Hydromodification and Hydrologic Controls

Ventura County Co-Permittee Comments

April 18, 2008

Figure 1:

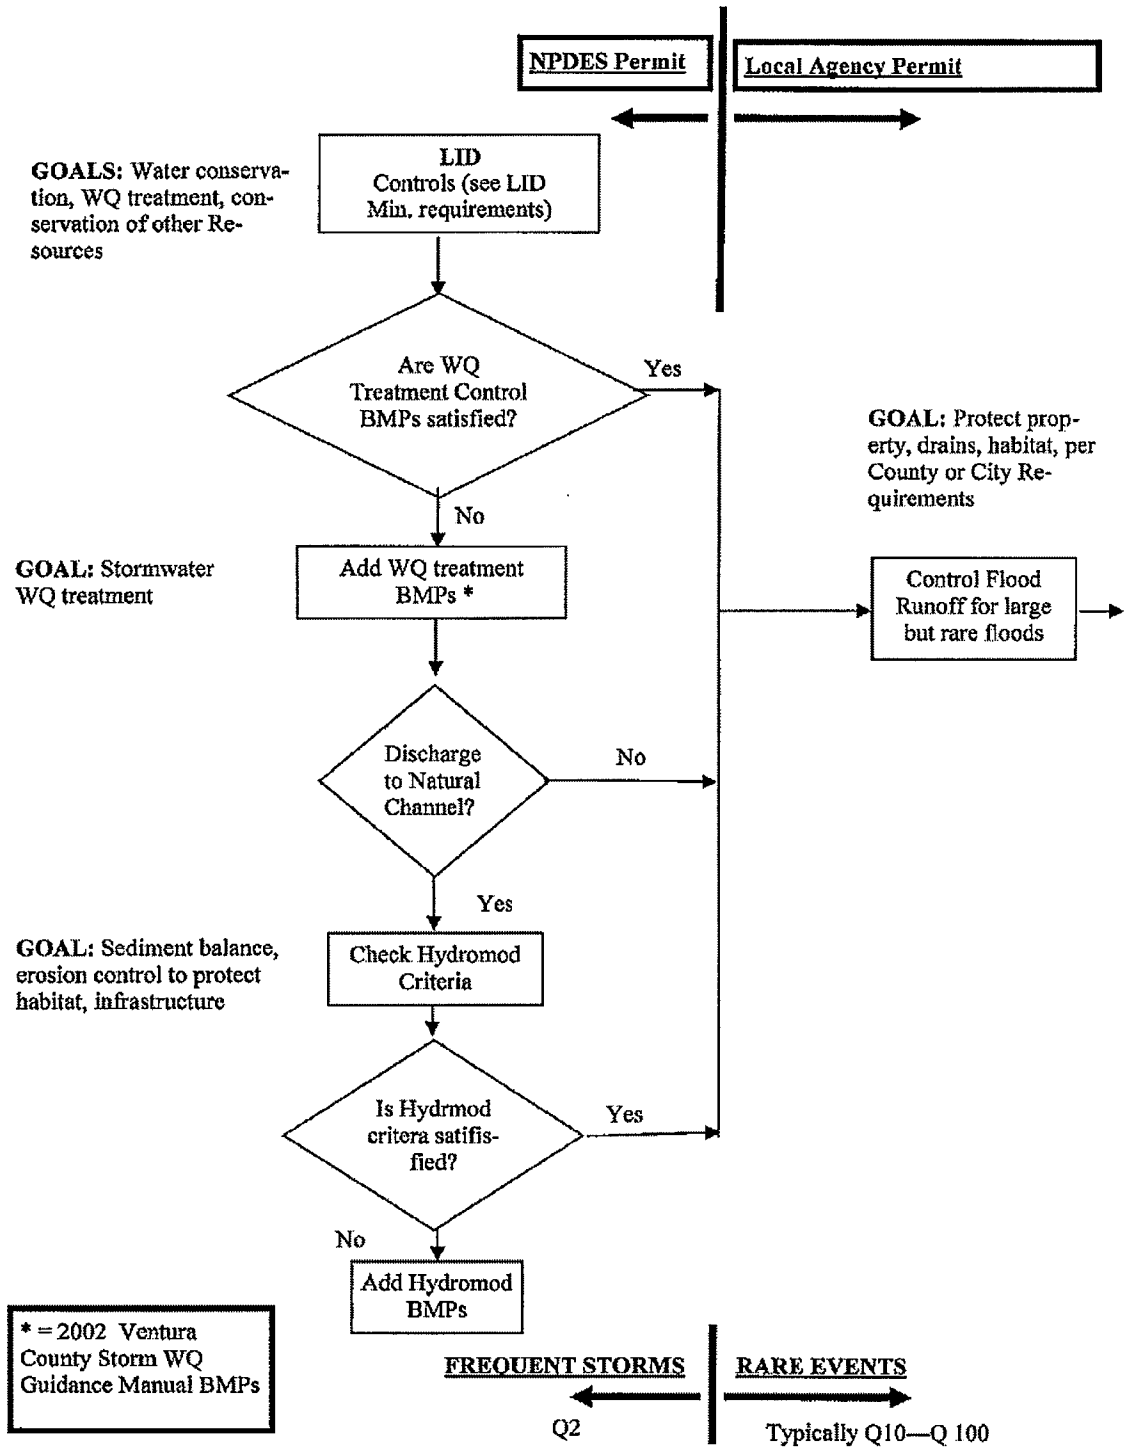
The permit should recognize the interdependence of hydrologic controls and a sequencing of analysis to take this into account - beginning with what can be done with LID measures, then check for water quality mitigation and finally Hydromodification for any remaining runoff. See

recommended flow chart in **Figure 1**. The Ventura County Technical Guidance Manual and Section 5.E.III.1 should be modified to add this recognition and flow chart for hydrologic controls to the permit. Suggested language is in Attachment C.

Figure 1.13: Factors affecting channel degradation and aggradation. The "size" of the channel is determined by the stream's energy, the slope, and the flow of water in balance with the size and quantity of the sediment particles the stream moves.

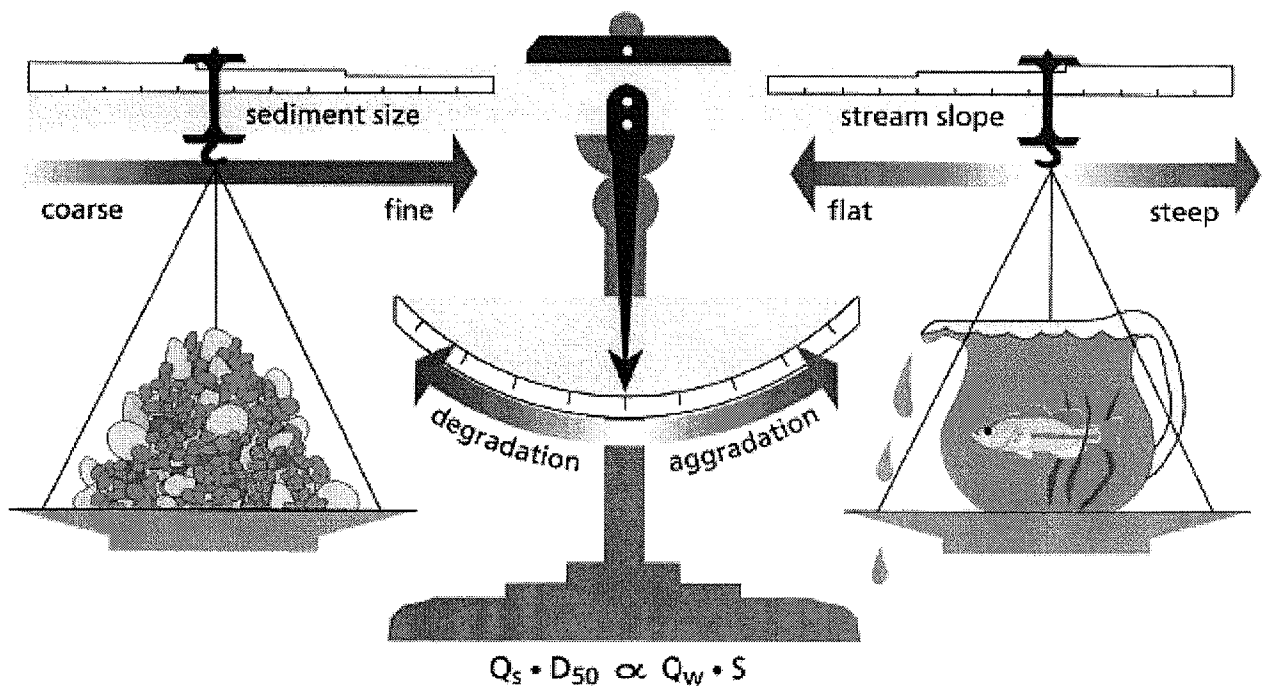
The 2nd draft permit addresses the issue of Hydromodification of natural stream channels by considering only flow rates and duration. The complimentary and necessary issue of sediment balance is ignored. Regulating the combination of flows and sediment to preserve downstream habitat and channels should be the goal of the Final Hydromodification criteria. **Attachment A** shows how both sediment and flow are related in degrading (cutting) or aggrading (building) downstream channels.

An unintended consequence of the Interim Hydromodification criteria in the 2nd Draft Permit can be an increase in downstream erosion of habitat and stream channels because of ignoring the cumulative influence of LID and Treatment BMP's on sediment transport. The permit only addresses water shear forces and does not consider the sediment balance issue.

LID and Treatment BMPs in the 2nd Draft Permit dictate that post-project peak outflow from a project area be equal to or less than existing peak outflow, by allowing some storage, infiltration, consumption, or treatment. This has the effect of settling sediments so that sediment outflow with a project that has LID and/or Treatment BMPs is less than the pre-project sediment outflow. This clearer "sediment hungry" discharge created by the LID or BMPs erodes downstream habitat, stream channels, and "starves" beaches of sand. Taking this to the extreme shows the extent of the unintended consequence: to obtain the natural sediment load downstream of a LID site or Treatment BMP, sediment would have to be collected at the project site, transported downstream, and then re-injected to the stream.
